Access Compliance Report
Public Rights-of-Way
(Pedestrian Signals)

Intersection ID: N/A	Main Street:		Cross Street: N/A		Location: N/A

ADA ID: F2555E000BC3 | **Signal Type:** Two Push Buttons-Non APS | **Overall Compliance:** No | **Severity Score: BTN 1:** N/A | **BTN 2:** N/A | **No BTN:** N/A

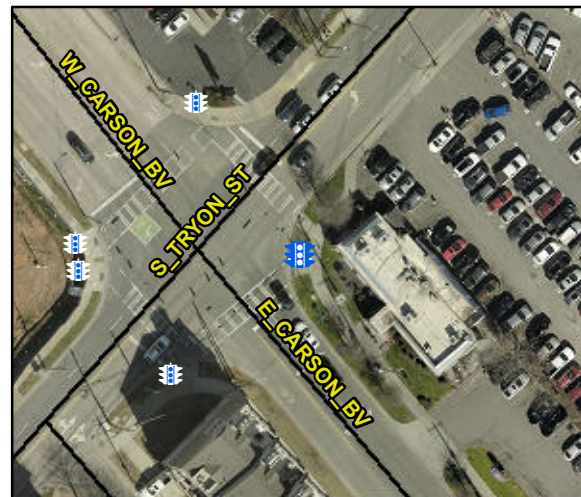
PROW/ADA: R404.1, R406.2, R404.7.3, TMUTCD 4e.08, R406

N/A	B 1 FWD Approach Width (in)	N/A	N/A	B 2 FWD Approach Width (in)	N/A
N/A	B 1 FWD Approach Obstruction?	Yes	N/A	B 2 FWD Approach Obstruction?	Yes
N/A	B 1 FWD Approach Obstruction Dist (in)	9.0	N/A	B 2 FWD Approach ObstructionDist (in)	N/A
N/A	B 1 PARA Approach?	Yes	N/A	B 2 PARA Approach?	Yes
N/A	B 1 PARA Approach Constrained?	No	N/A	B 2 PARA Approach Constrained?	No
No	B 1 PARA Approach Reach (in)	12.0	No	B 2 PARA Approach Reach (in)	16.0
N/A	B 1 PARA Approach Width (in)	N/A	N/A	B 2 PARA Approach Width (in)	N/A
N/A	B 1 PARA Approach Obstruction?	Yes	N/A	B 2 PARA Approach Obstruction?	Yes
N/A	B 1 PARA Approach Obstruction Dist (in)	9.0	N/A	B 2 PARA Approach ObstructionDist (in)	10.0
N/A	B 1 Clear Floor Space Slope (%)	9.1	N/A	B 2 Clear Floor Space Slope (%)	1.5
N/A	B 1 Clear Floor Space XSlope (%)	1.1	N/A	B 2 Clear Floor Space XSlope (%)	9.4
N/A	B 1 PAR Slope (%)	8.4	N/A	B 2 PAR Slope (%)	2.3
Yes	B 1 Height (in)	48.0	No	B 2 Height (in)	49.0

Yes	B 1 Clear Xing Direction?	ClearlyMarked	Yes	B 2 Clear Xing Direction?	ClearlyMarked
	B 1 Crossing Direction	To SW		B 2 Crossing Direction	To NW
Yes	B 1 DistanceTo XWalk (in)	0.0	No	B 2 DistanceTo XWalk (in)	103.0
Yes	B 1 DistanceTo Curb (in)	69.0	Yes	B 2 DistanceTo Curb (in)	69.1
Yes	B 1 Diameter (in)	2.0	No	B 2 Diameter (in)	2.0

Possible Solutions: Provide Push Button Extension. Provide Clear Space. Replace Signal Push Button With APS Button on New Post. Remove & Relocate Sign.
